SEWAGE DISPOSAL SYSTEM

HOWARD COUNTY
BUREAU OF ENVIRONMENTAL HEALTH
992-2330

SUBDIVISION Chestnut Hill Estates ROAD 8227 Church Lane LOT 6, Sec. 2

November 30, 1983

PERMIT CARD Church Lane Road

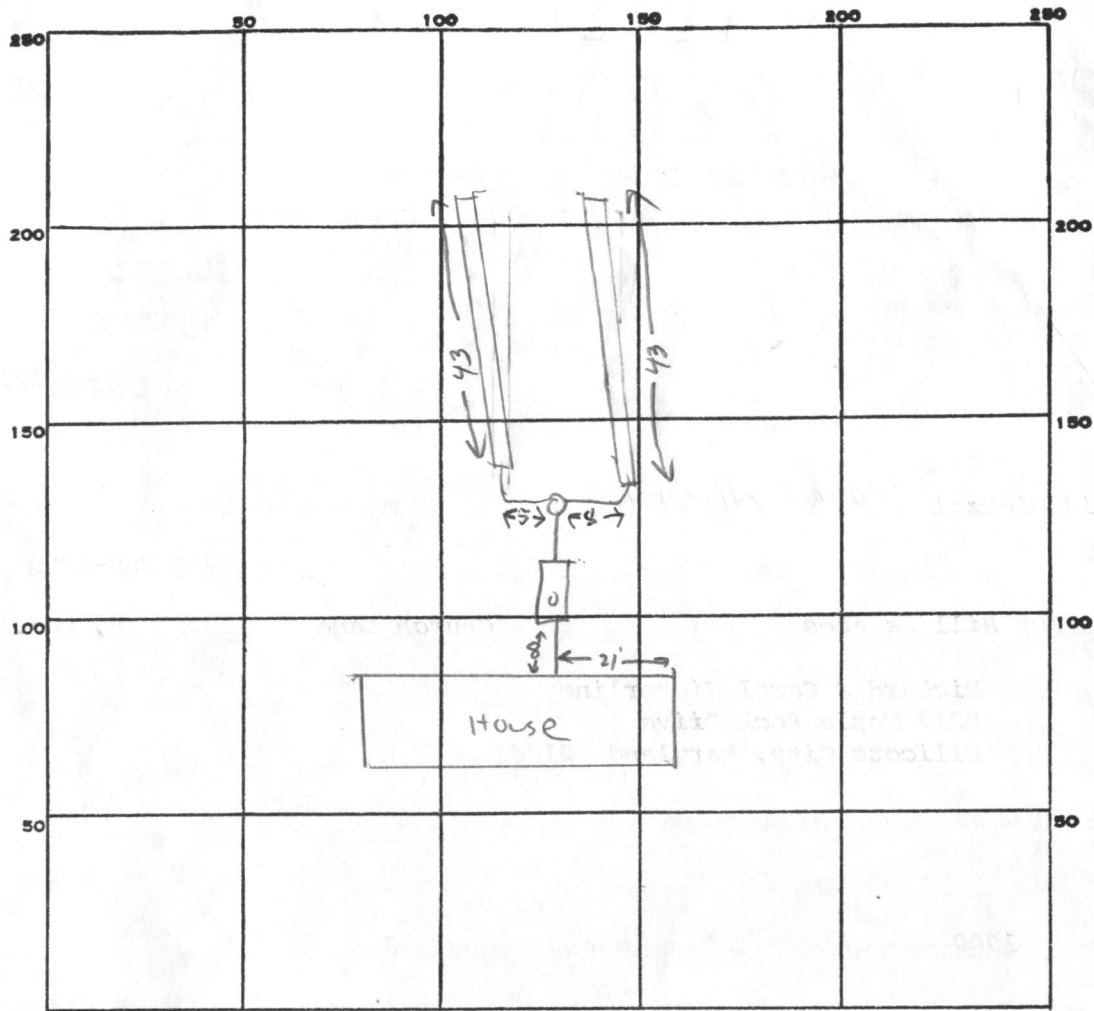
TRENCHES - 200 sq. ft. absorbant sidewall per bedroom. Trench to be 2 feet wide, Inlet 4 feet below original grade. Bottom maximum depth 11 feet below original grade. Effective area begins at 4 feet below original grade with 7 feet of stone below distribution pipe. LOCATION: Start the first trench 65 feet from the rear lot line and 65 feet from the leftside line as seen when facing the lot from Church Lane. Continue to dig the trench on level ground running towards the left rear corner of the lot. Place the second trench parallel to and 14 feet away from the first trench. NOTE: No trench to exceed 100 feet in length. If more than one trench used, a distribution box is required. Trenches to be installed on level ground. Call for inspection of trench before and after gravel is installed. Provide 6"-8" diameter cleanout and cap to grade or above on septic tank and drywell.

REMARKS 5-24 O.k. to cover all work AJ

RE: Building Permit Serial #56606

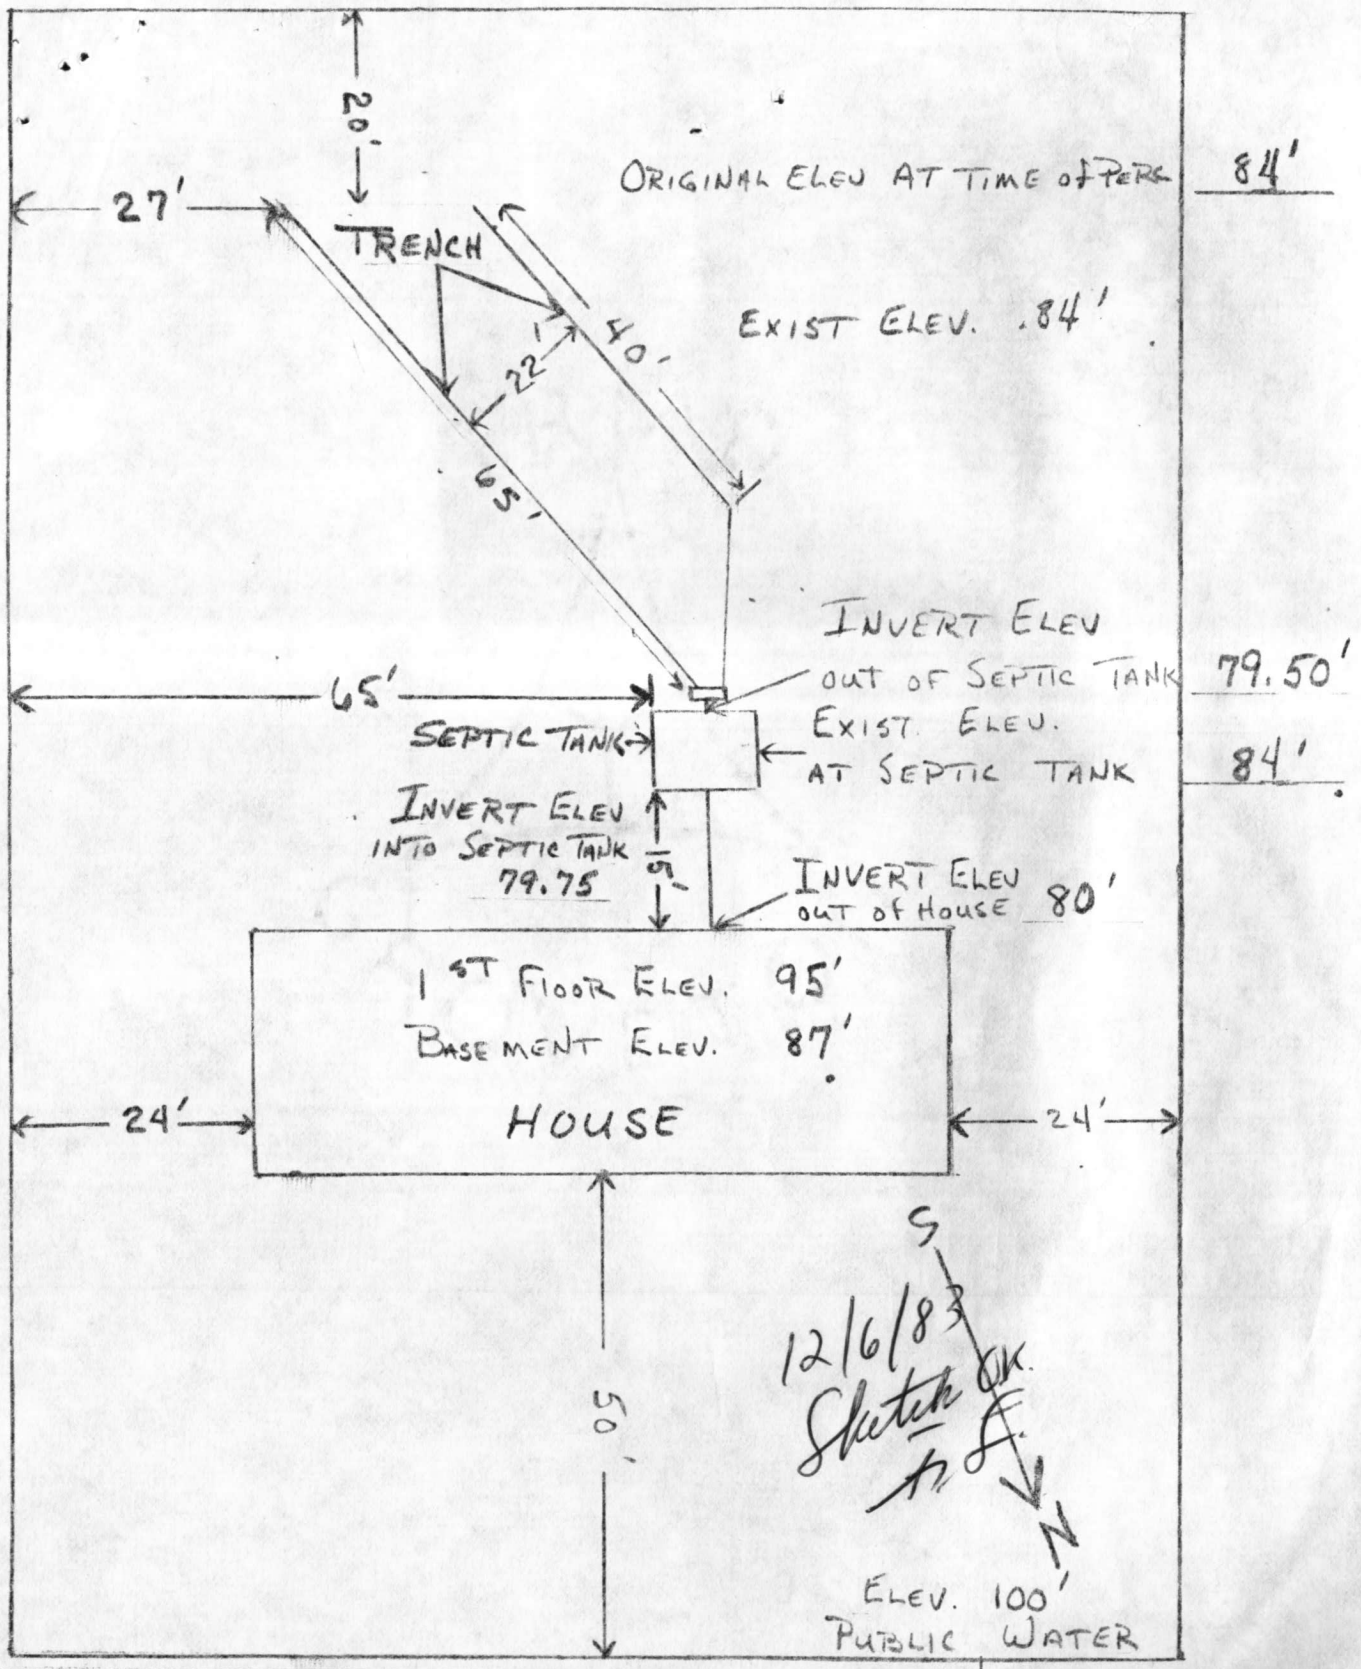
This office has received the above referenced building permit application, but cannot approve it until a more detailed site plan is received and approved.

I have enclosed information useful in completing this plan.
